TSB REVISION NOTICE:

Introduction Some customers may complain that the cover on the side of the seat back pulls away from the bezel for the access lever or reclining adjuster lever. Parts have been modified to correct this condition. Please refer to the following repair procedure to correct affected vehicles.

- Applicable Vehicles**
- **2005 – 2006** model year **Scion tC** vehicles produced **BEFORE** the Production Change Effective VIN shown below.

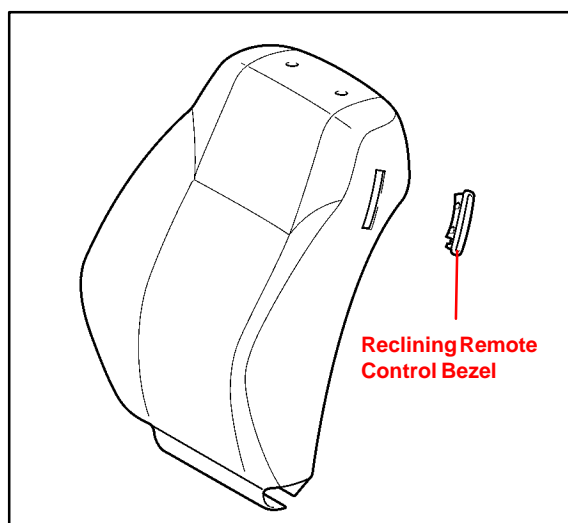
1. Remove the reclining adjuster release handle.

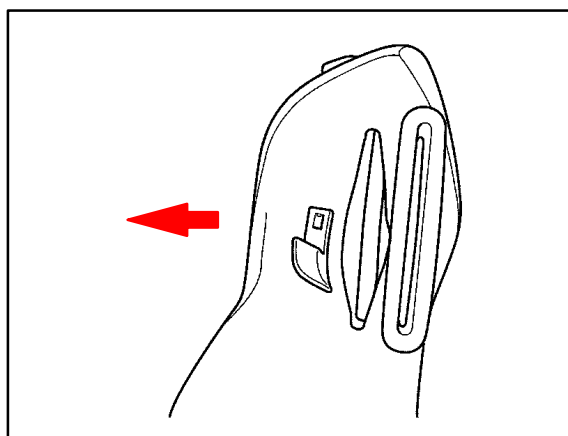
2. Remove the reclining control bezel.

- Gently pull the control bezel to remove.
- Be sure to NOT damage the bezel during removal.

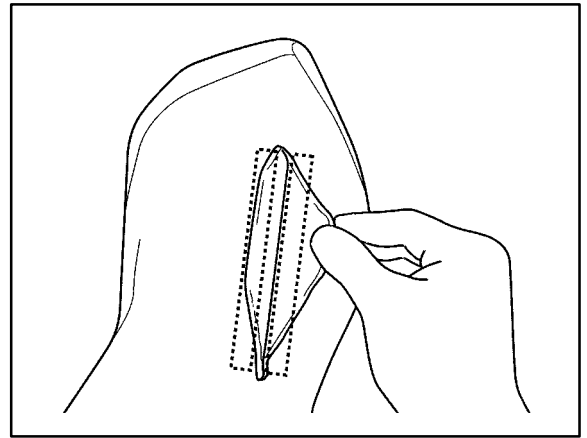
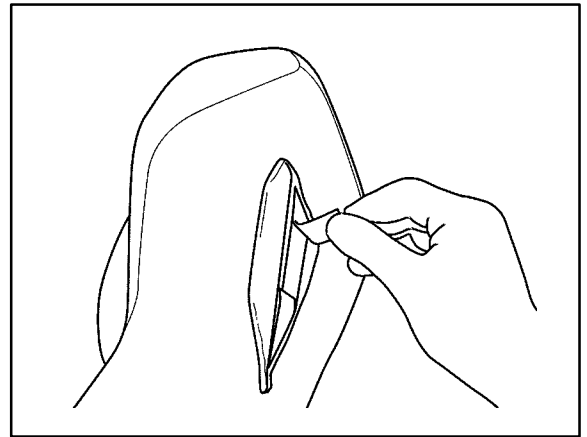
3. Apply double-sided tape to the seat pad for the front seat back cover fitting (for front and rear).
Apply the double-sided tape along the outer edge of the seat pad opening.

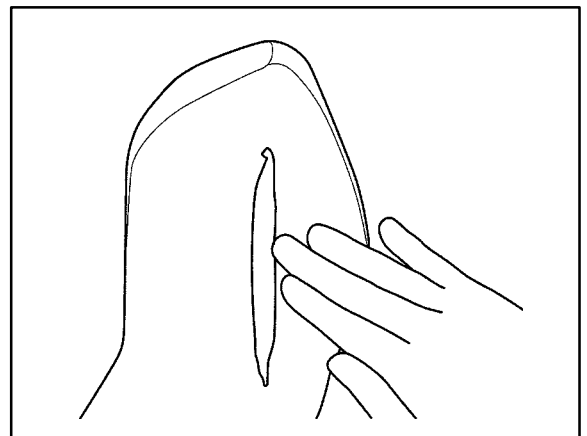
4. Carefully remove the backing from one side of the double-sided tape.

5. Press the front seat back cover against the tape adhesive side.

- Do NOT attempt to remove the tape once applied to the cover.
- Do NOT reuse the tape if removed once.

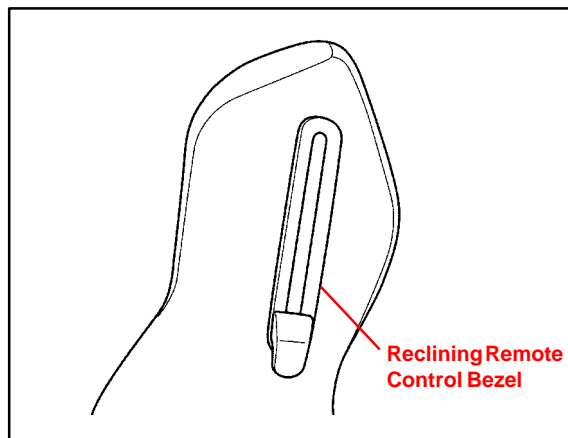
6. Install the reclining control bezel by pressing it firmly into place.

Allow it to set for 30 minutes for proper adhesion.
